**SUSQUEHANNA STEAM ELECTRIC STATION  
PROPOSED LICENSE AMENDMENT NO. 285  
FOR UNIT 1 OPERATING LICENSE NO. NPF-14  
AND PROPOSED LICENSE AMENDMENT NO. 253  
FOR UNIT 2 OPERATING LICENSE NO. NPF-22  
EXTENDED POWER UPRATE APPLICATION  
SUPPLEMENT TO REQUEST FOR ADDITIONAL  
INFORMATION RESPONSES  
PLA-6230**

**Docket Nos. 50-387  
and 50-388**

**The following provides the responses to NRC Questions 3, 4 and 8 contained in the Request for Additional Information Responses transmitted to NRC in References 2. The NRC Question and PPL Response for each is provided below.**

**Figure 4.3 Microscopic Thermal Cross Section of U-235 at Beginning of Life**

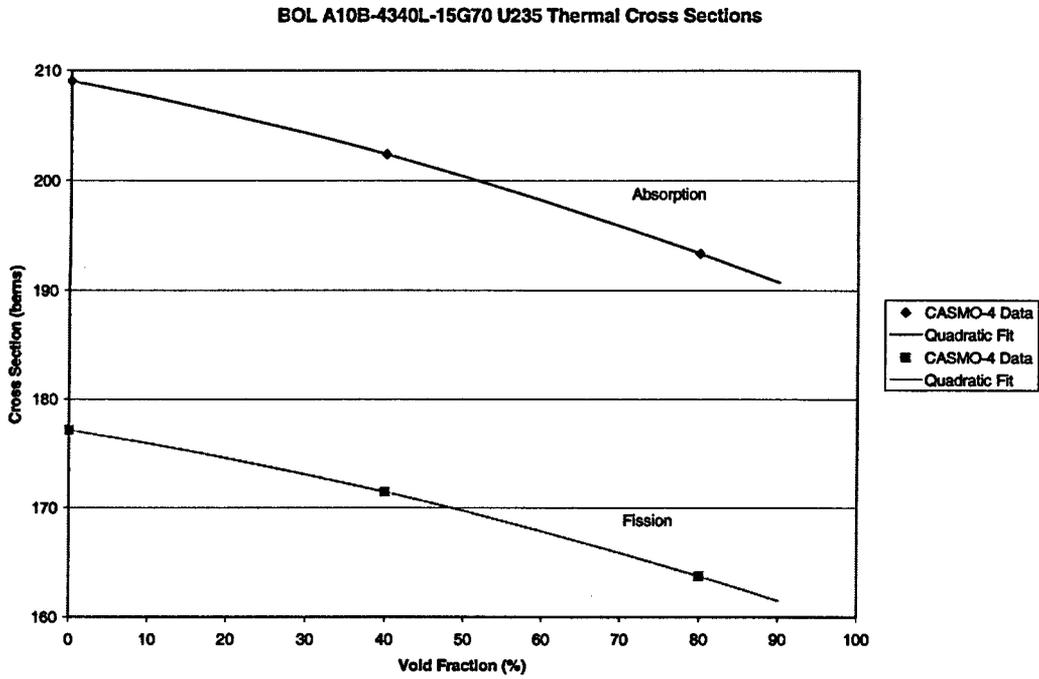
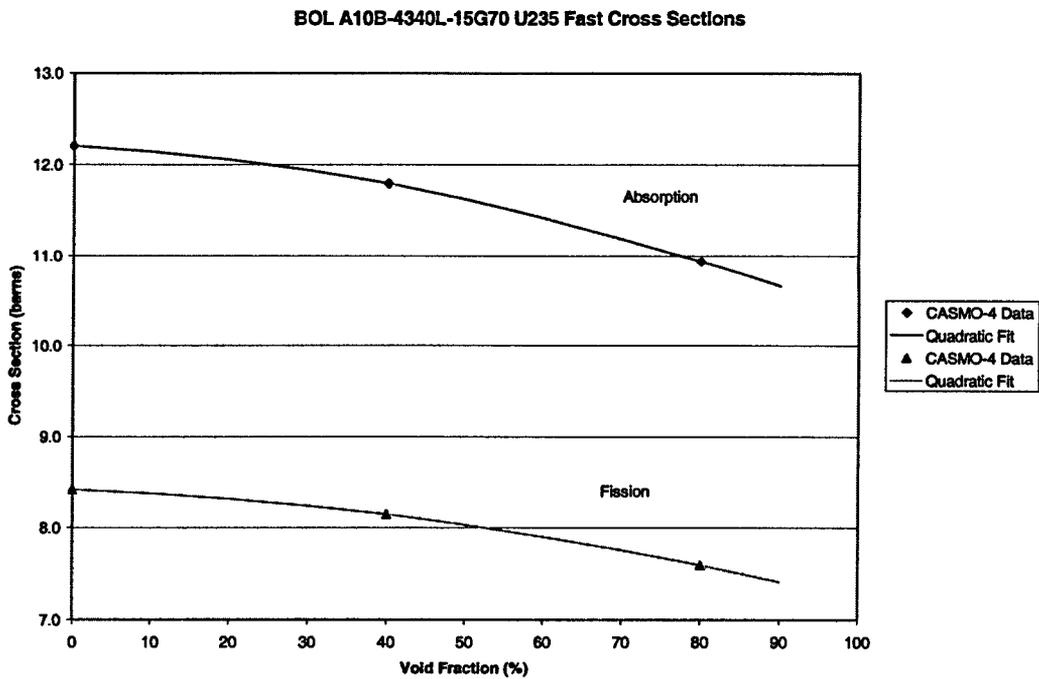
(Nuclear Design): Provide plant and cycle specific information to show that the CASMO-4/MICROBURN-B2 code system was applied in a manner such that the predicted results for SSES 1 and 2 constant pressure power uprate analysis were within the range of the measurement uncertainties presented in EMF-2158(P)-A, "Siemens Power Corporation Methodology for Boiling Water Reactors: Evaluation and Validation of CASMO-4/MICROBURN-B2."

At BOL the relationship is fairly simple, the cross section is only a function of void fraction (water density) and the reason for the variation is the change in the spectrum due to the water density variations. At any exposure point, a quadratic fit of the three CASMO-4 data points is used to represent the continuous cross section over instantaneous variation of void or water density. This fit is shown in Figure 4.3 and Figure 4.4.

**Figure A.2 0.7 ft<sup>2</sup> PD SF-BATT TOP 108F  
Total Break Flow Rate**

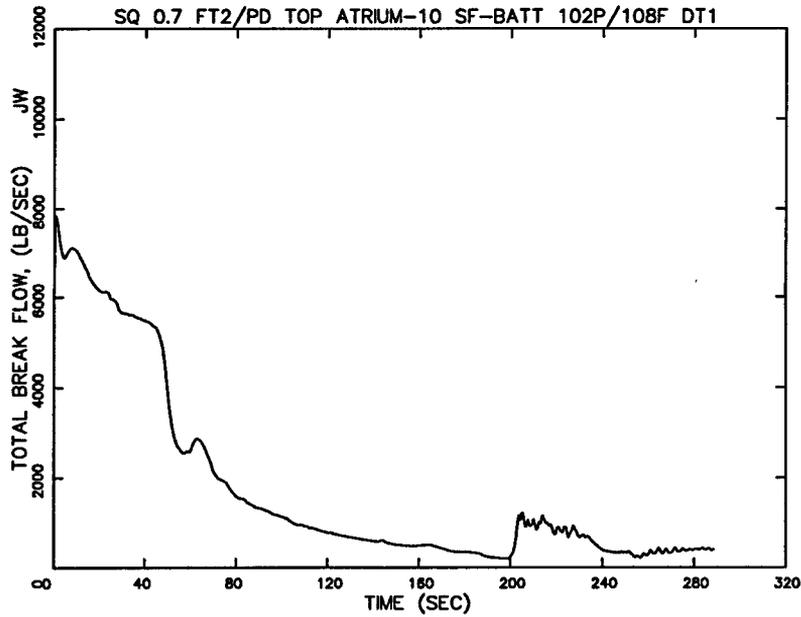
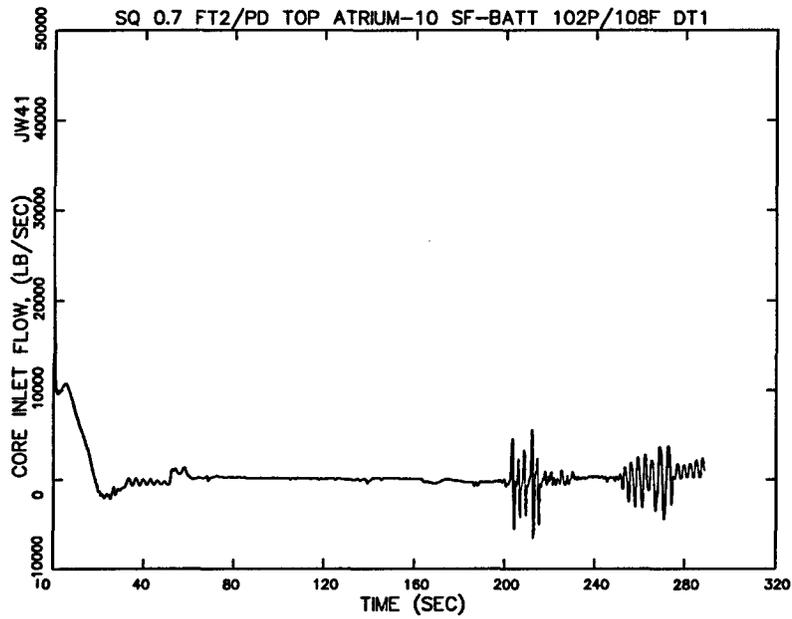
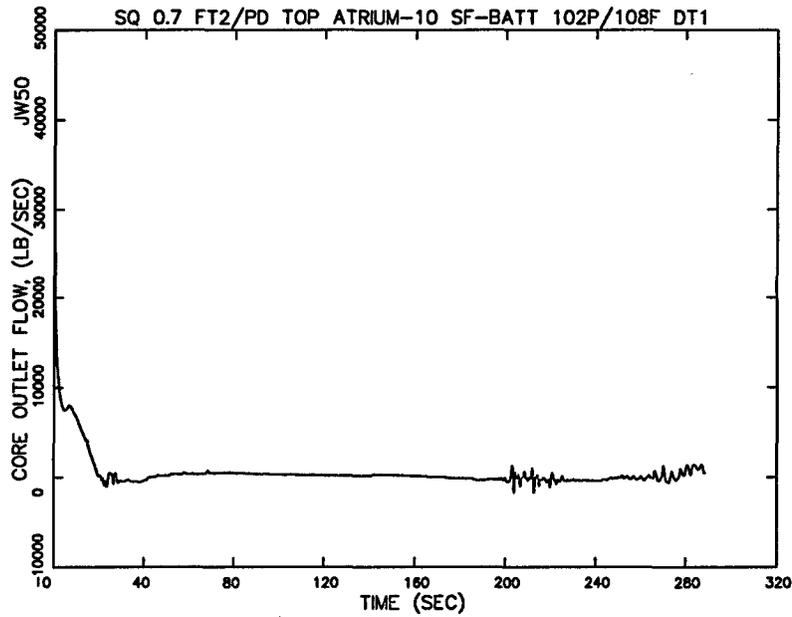
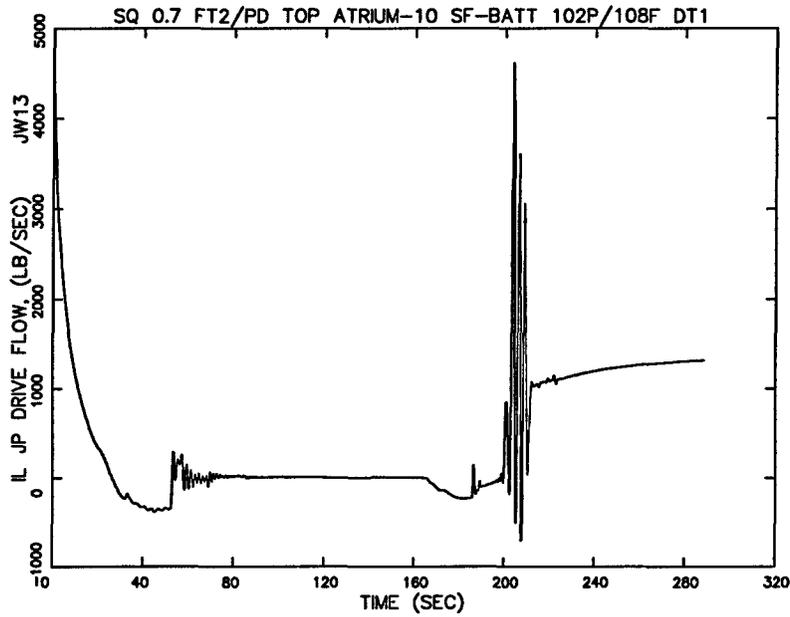
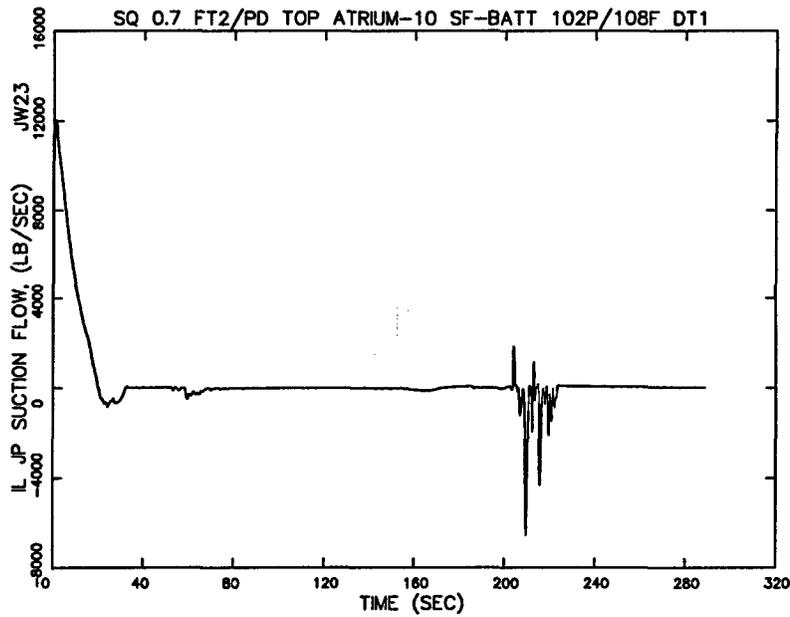
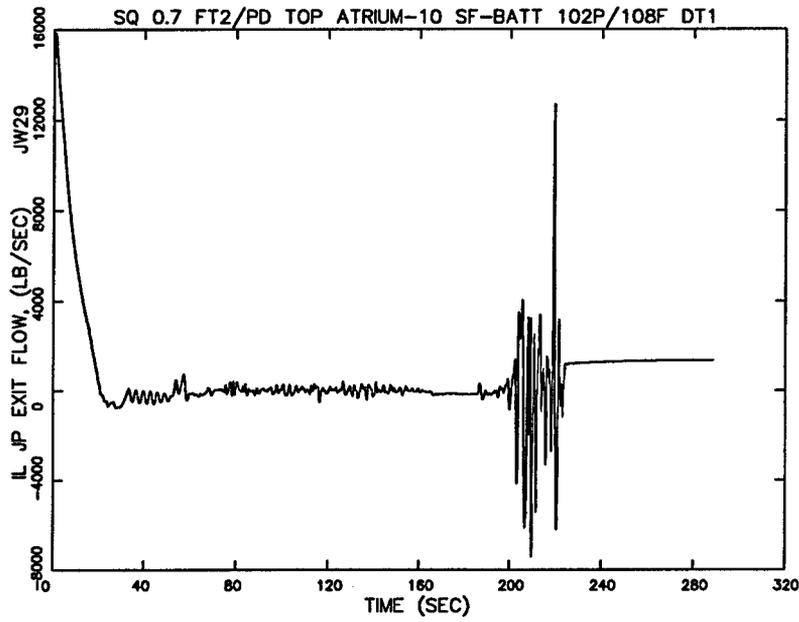
The NRC staff would like to confirm that the Susquehanna small break LOCA PCT result is not limiting compared to large break LOCA result. Specifically, the NRC staff requests PPL to provide the following information for the most limiting small break LOCA case (SF-BATT, 0.7 ft2 split, top peak, pump discharge break).

- 1.1. Plant initial condition, axial power shape, radial peaking and local peaking factors.
- 1.2. Sequence of events.
- 1.3. Break size, ECCS flows and locations including HPCI, LPCI, LPCS and ADS.
- 1.4. Major parameter plots similar to large break LOCA results (Figure 6.1 to 6.27 in EMF-3242P)

The break size is precisely 0.7 ft<sup>2</sup> in the piping connected to the recirculation pump discharge (PD). The break occurs during full power operation at the CPPU power stated in Table A.1, a core flow of 108 Mlbm/hr, and the top peaked axial power profile depicted in Figure 4.5 of EMF-3242(P). The single ECCS failure in this analysis is the DC power supply, designated SF-BATT. For a PD break with SF-BATT, the available ECCS are ADS, one of two LPCS systems, and one LPCI pump injecting into the intact loop. No HPCI flow is available for the SF-BATT scenario. Figure 4.2 of EMF-3242(P) shows the locations for fill junctions used to represent HPCI, LPCI, LPCS, and ADS in the RELAX model. Plots of the flow versus time for each of these systems are included in the set of parameter plots requested in NRC Question 3 of Reference 4.

**Figure A.28 0.8 DEG PS SF-LPCI TOP 108F  
Upper Plenum Pressure (Lower)**

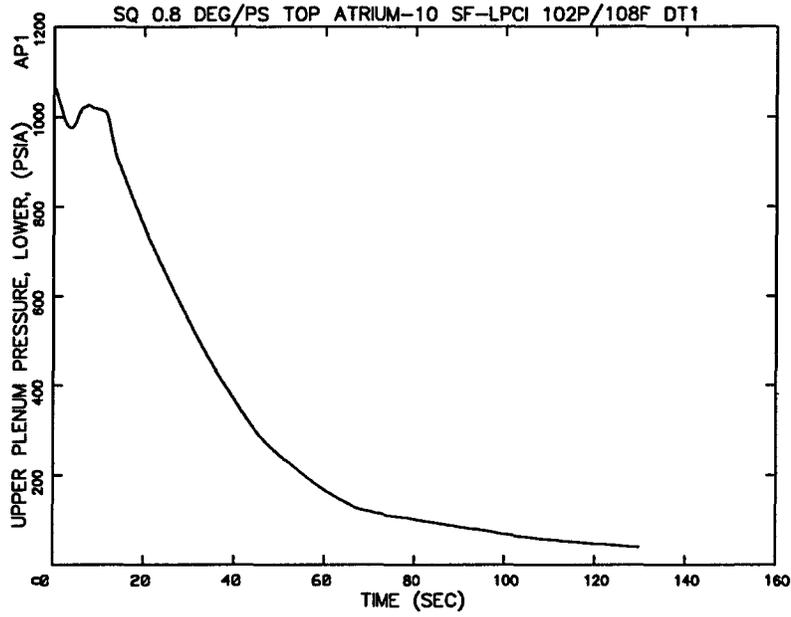
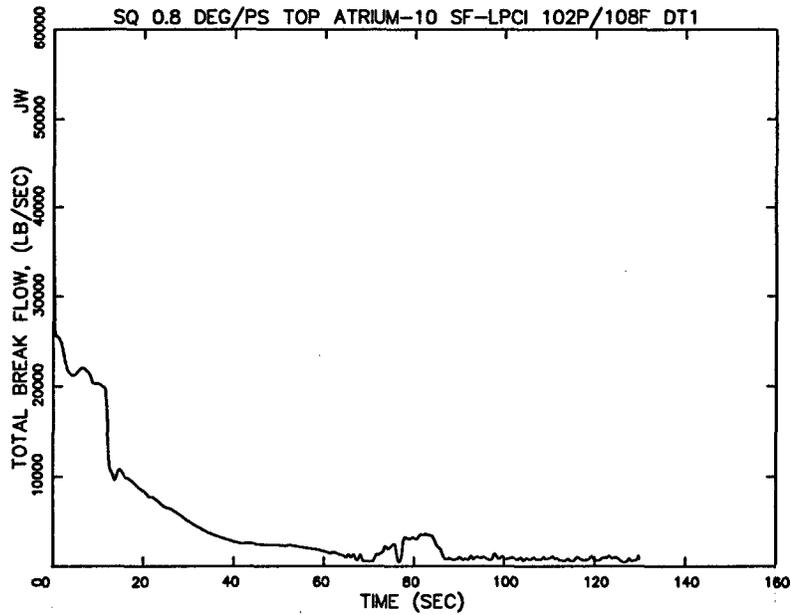
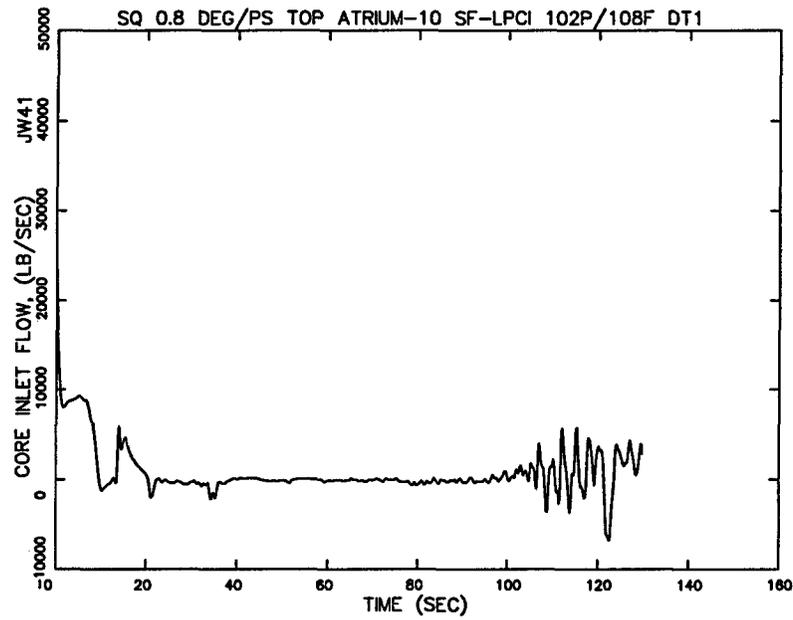
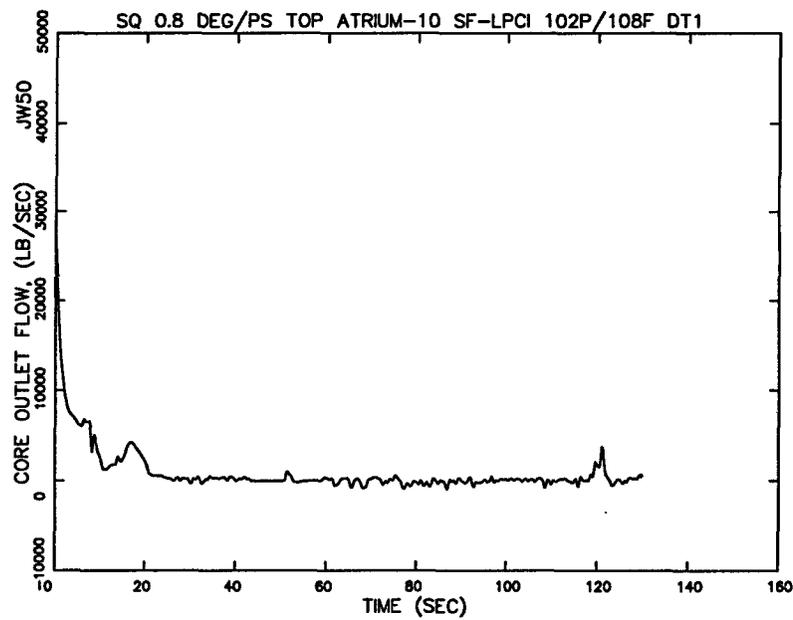
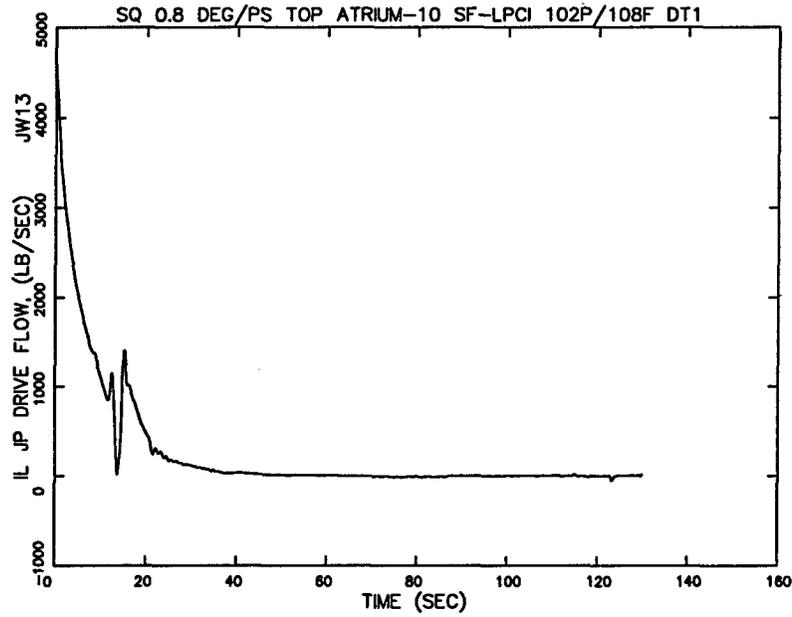
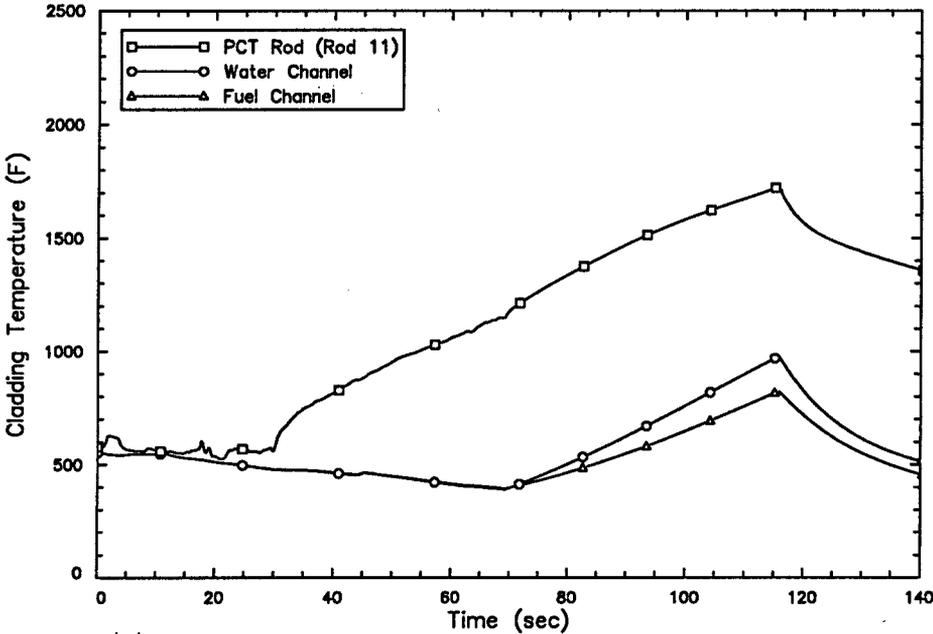
Per Table 6.9 of EMF-3242(P), the limiting LOCA for two-loop operation and a core flow of 108 Mlbm/hr is the 0.8 DEG pump suction (PS) break with SF-LPCI and top peak. Provide the corresponding major parameter plots similar to Figure 6.1 to 6.27 in EMF-3242(P).
